COMPANY: TINNO MOBILE TECHNOLOGY CO.,LTD				
TITLE:				
B11 DUO BB_MT6252A_DIGITAL				
CODE:	SIZE:	DRAWING NO:		REV:
	C	B11 DUO		
SCALE: <Scale>			SHEET: 6	6

COMPANY: TINNO MOBILE TECHNOLOGY CO.,LTD			
TITLE: B11 DUO MCM,TFR,IO			
CODE:	SIZE:	DRAWING NO:	REV:
	C	B11 DUO	
SCALE: <Scale>			SHEET: 3 6

COMPANY: TINNO MOBILE TECHNOLOGY CO.,LTD			
TITLE: B11 DUO RFP, SIM			
CODE:	SIZE: C	DRAWING NO: B11 DUO	REV:
SCALE: <Scale>		SHEET: 5 6

JTAG

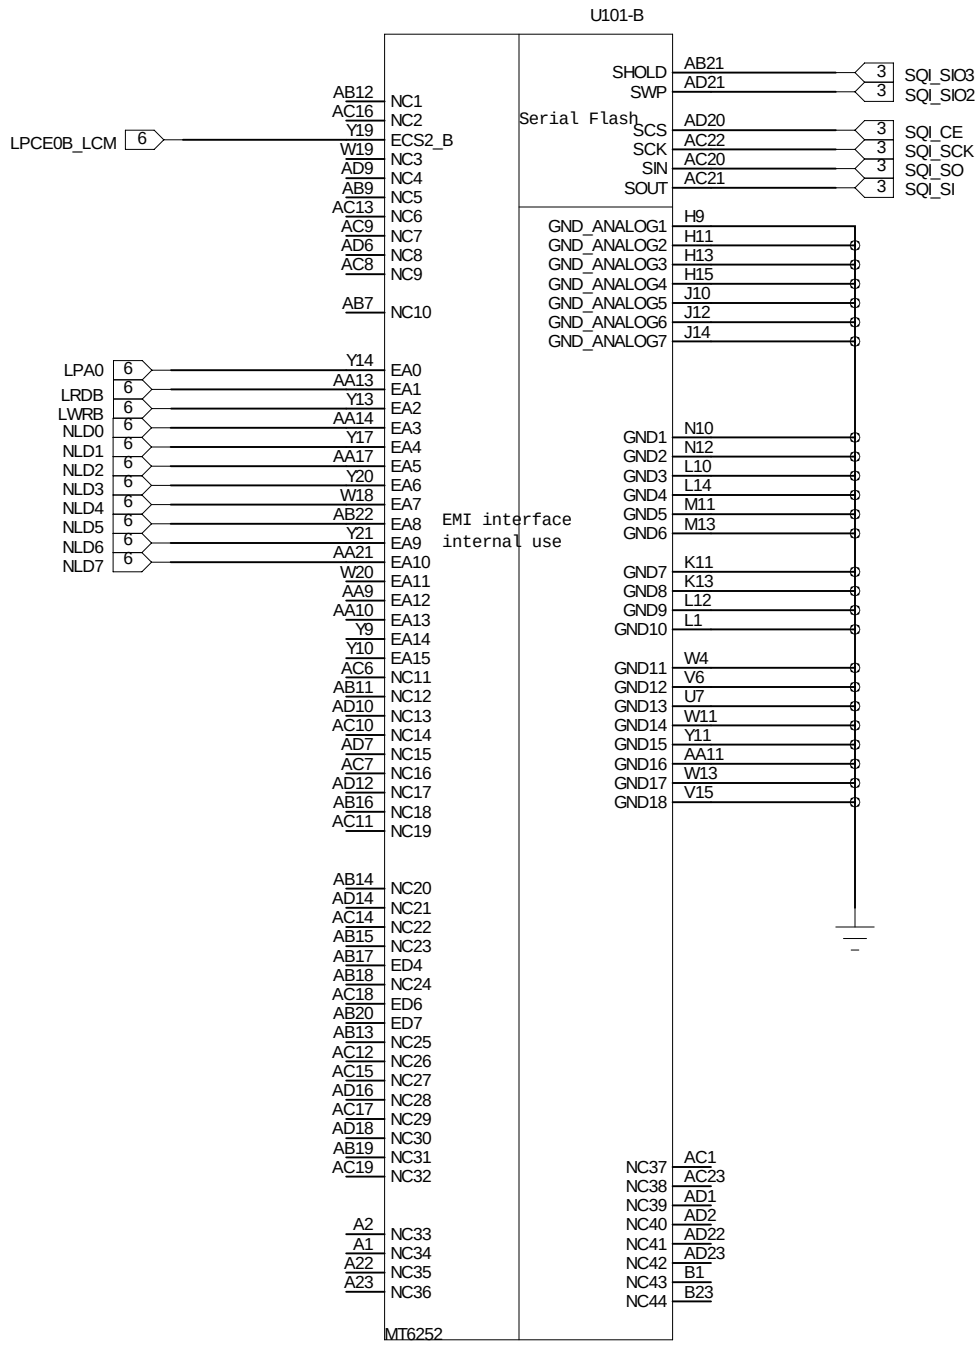
If BT is not turned on , please confirm the internal pull down resistor should be enabled.
